Southern Nuclear Operating Company
Vogtle Electric Generating Plant Unit 3
Request for License Amendment:
Column Line 7.3 Wall Reinforcement Area Change (LAR-16-024)

Enclosure 1

Column Line 7.3 Wall Reinforcement Area Change

(LAR-16-024)

Figure 1: Detailing Repair

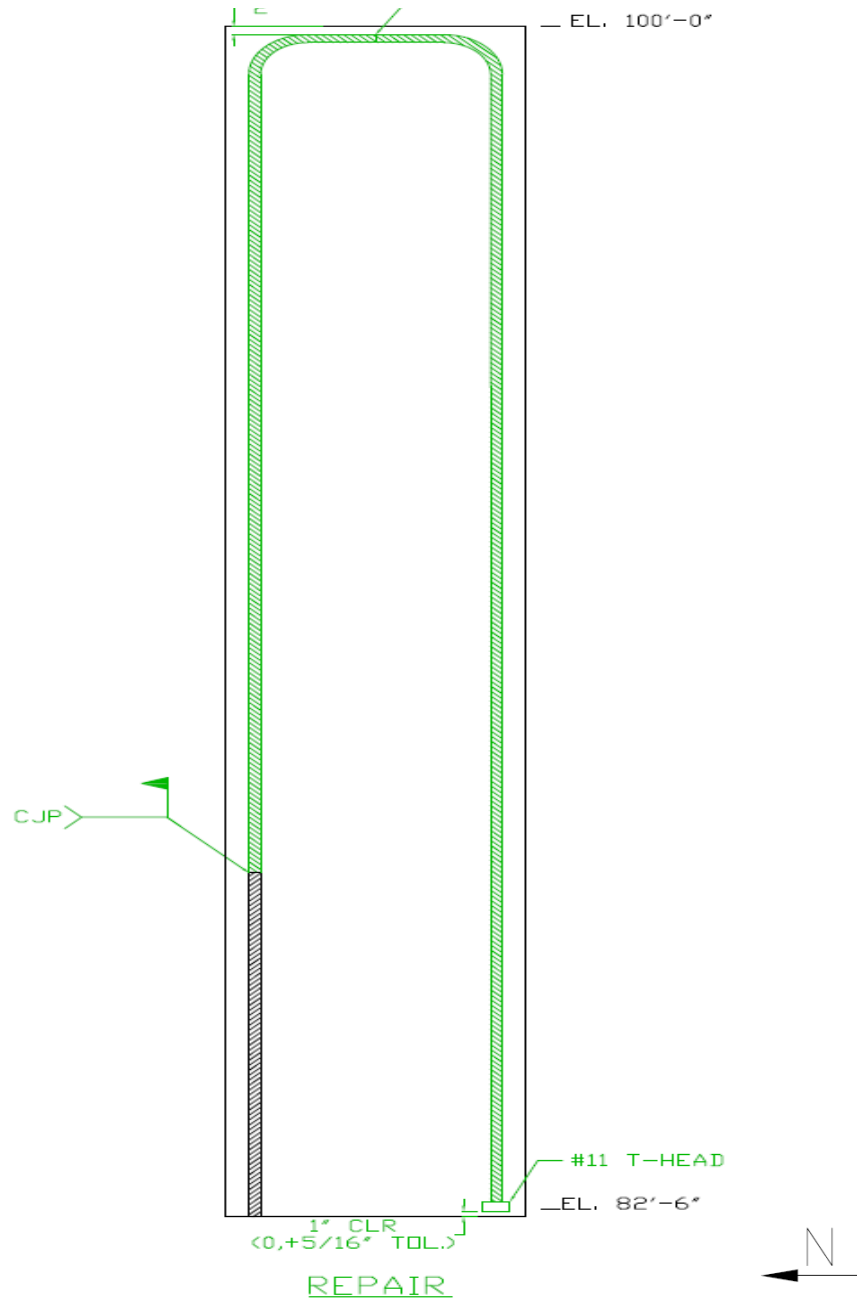
After the omission of the bar was identified, a repair was developed in compliance with American Concrete Institute (ACI) 349-01 "Code Requirements for Nuclear Safety Related Concrete Structures" for Vogtle Unit 3. The repair uses a U-bar welded to a dowel in the north face of the column line 7.3 wall and extends up to the 100'-0" elevation and comes back down to the 82'-6" elevation on the south face and terminates as a headed reinforcing bar to replace the missing dowel developing from below elevation 82'-6". This repair is to replace the omitted bar and restore the Vogtle Unit 3 column line 7.3 wall to 55 bars. A repair is not needed for Vogtle Unit 4 as 55 bars are developed below the construction joint at elevation 82'-6".

strength of the reinforcement bar per ACI 349-01 Section 12.14.3.3) and will function as one continuous bar. This repair acts as the omitted dowel and allows for continuous development of the reinforcement along the wall with lap splices per ACI 349-01 Chapter 12. This configuration is shown on Figure 1.

The additional U-bar is welded to the reinforcing bar on the north face of the Vogtle Unit 3 column line 7.3 wall and terminates on the south face as a headed reinforcing bar suspended at approximately elevation 82'-7". The headed reinforcing bar develops through bond and bearing along the development length. This bar acts for the missing dowel in the south face of the column line 7.3 wall, but it is not fully developed at elevation 82'-6". The additional headed bar is considered as a straight bar in terms of minimum spacing and splice lengths; however, the headed reinforcing bar is not fully developed until a distance above elevation 82'-6". Therefore, the south face of the Vogtle Unit 3 column line 7.3 wall cannot be credited for full reinforcement from elevation 82'-6", and the area of steel is reduced along the development length of the U-bar. The reduction of the minimum provided vertical reinforcement was evaluated for the design of the Vogtle Unit 3 column line 7.3 wall, and because this information is designated as Tier 2*, NRC approval is being requested.
